1 11/6/2026 - ADDENDUM NO. 1

EROSION CONTROL PLAN FOR: CASCADES BUSINESS PARK INFRASTRUCTURE IMPROVEMENTS - PHASE 1

A SITE LOCATED IN THE CITY OF NORTH BONNEVILLE, WASHINGTON

SHEET ID
C06
SHEET 17 OF 28

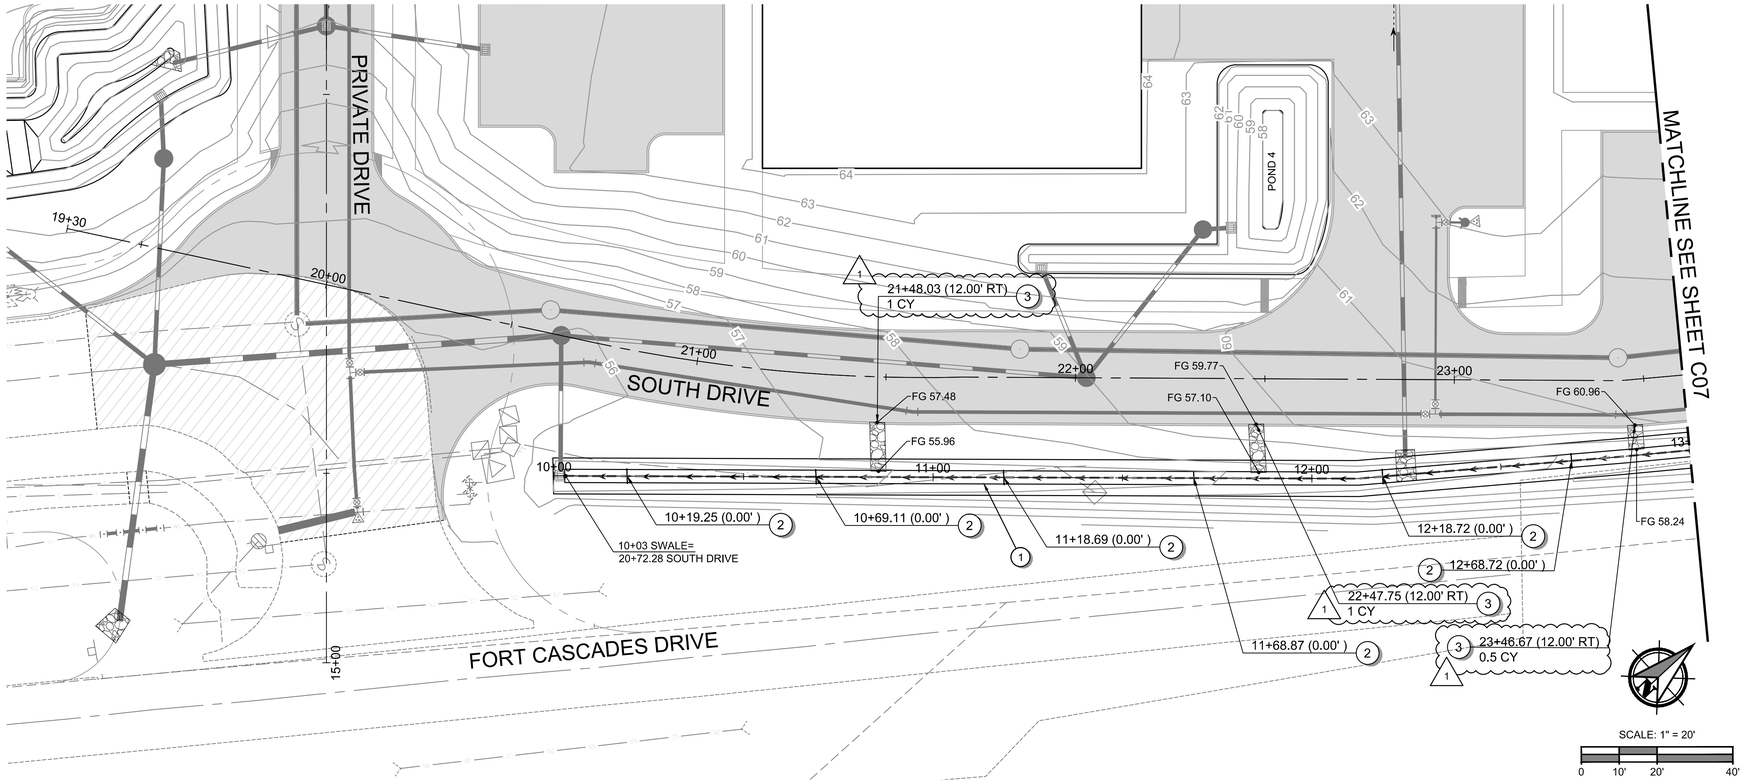
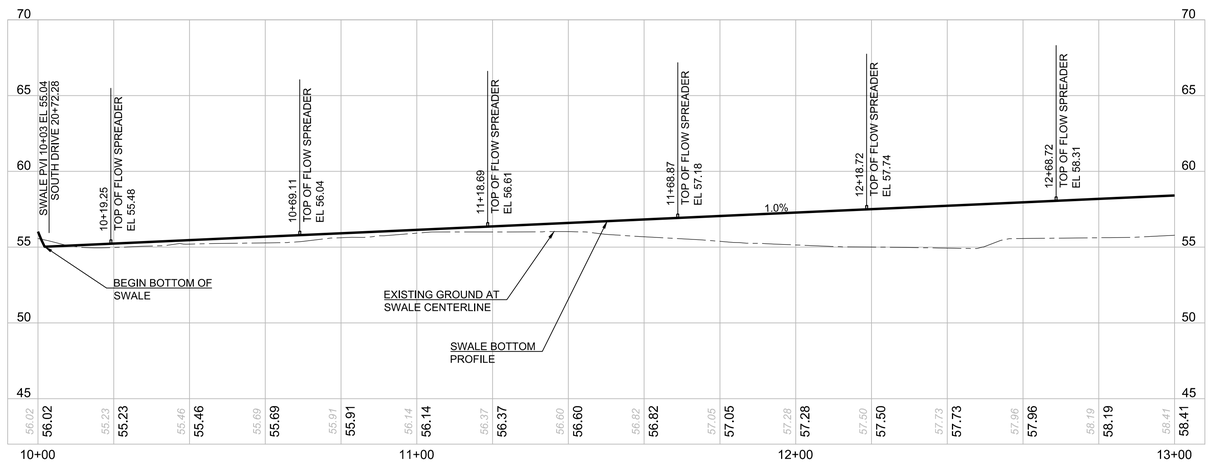
QUARRY SPALLS QUANTITIES ADDED.

DESIGNED:	ANT
CHECKED:	JBA
NOVEMBER 2026	78260.000
SHEET ID	C07
SHEET	18 OF 28

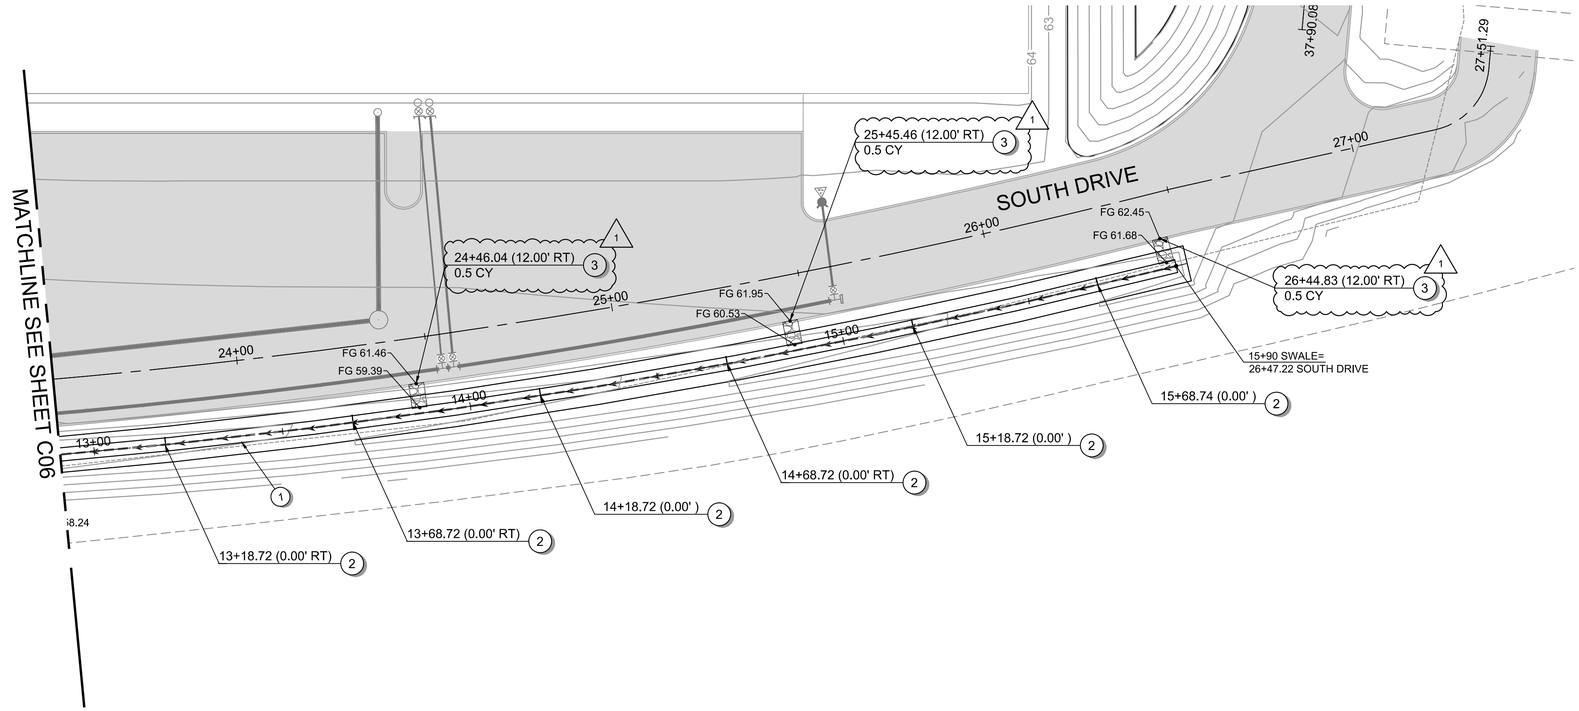
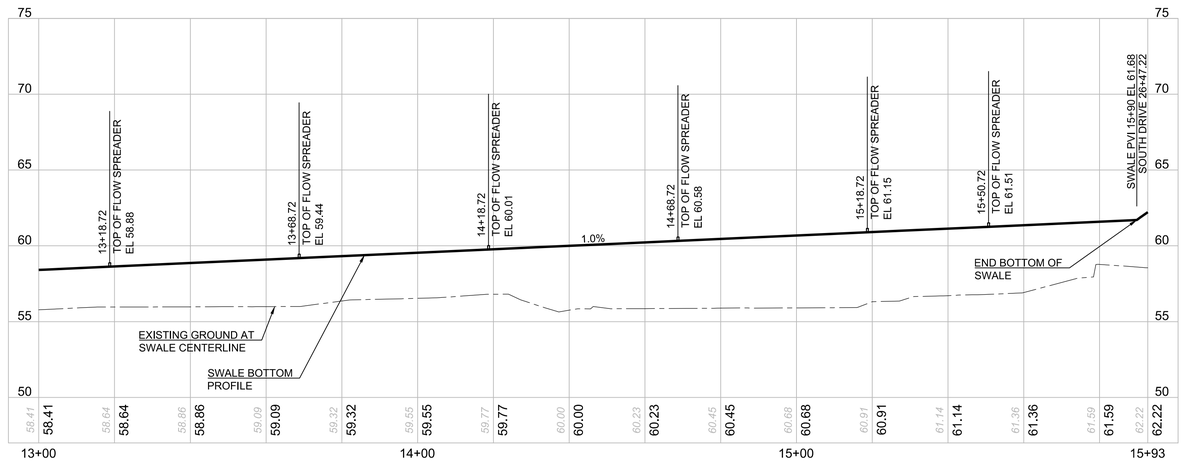
QUARRY SPALLS QUANTITIES ADDED.

DESIGNED:	ANT
CHECKED:	JBA
NOVEMBER 2026	78260.000
SHEET ID	UT01
SHEET	19 OF 28

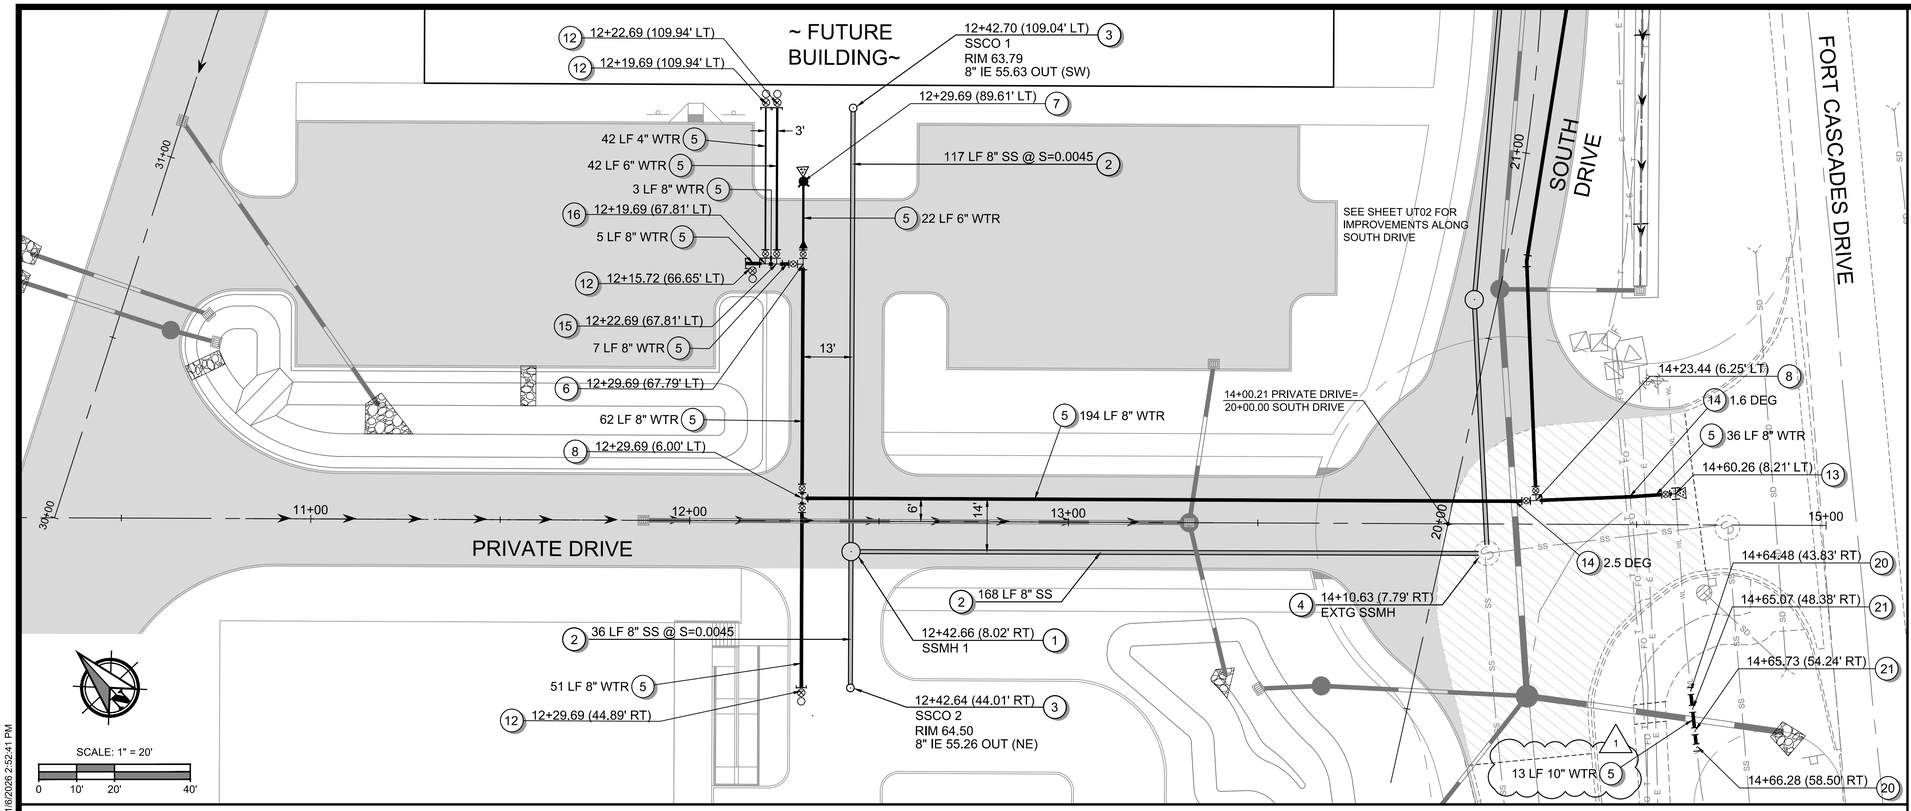
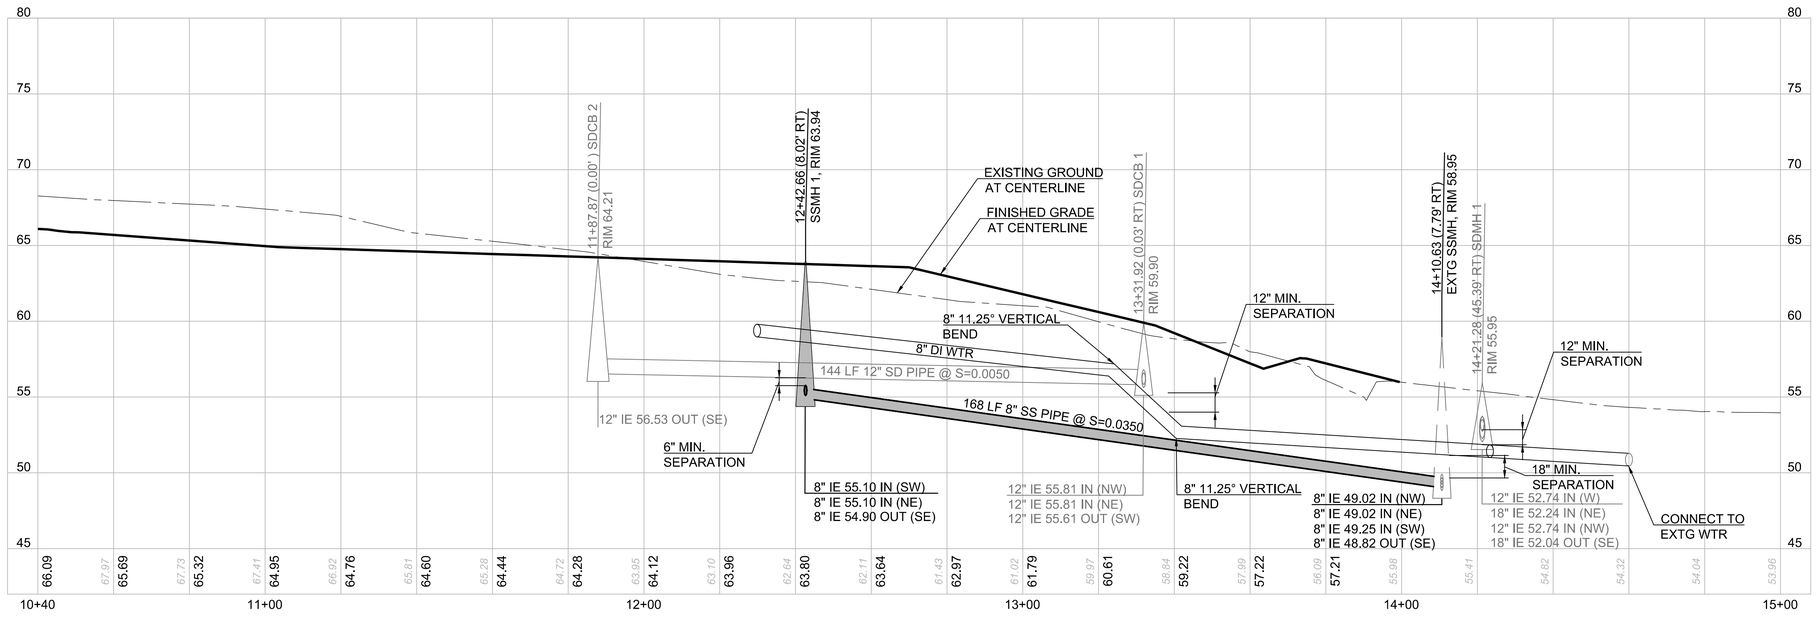
10 INCH PIPE QUANTITY ADDED BETWEEN BENDS.

Biofilter Swale Cross-Section Detail
NTS

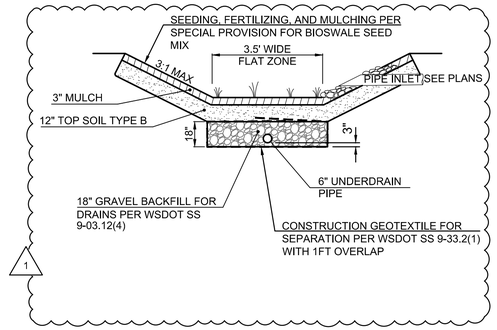
QUARRY SPALLS PAD DETAILS UPDATED TO SHOW POND CONDITION AND SWALE CONDITION. REFERENCE ADDED TO SEE PLANS FOR QUANTITIES. BIOFILTER SWALE PLANTING NOTE AND TOP SOIL NOTE UPDATED, GEOTEXTILE FOR SEPARATION ADDED AROUND DRAIN ROCK
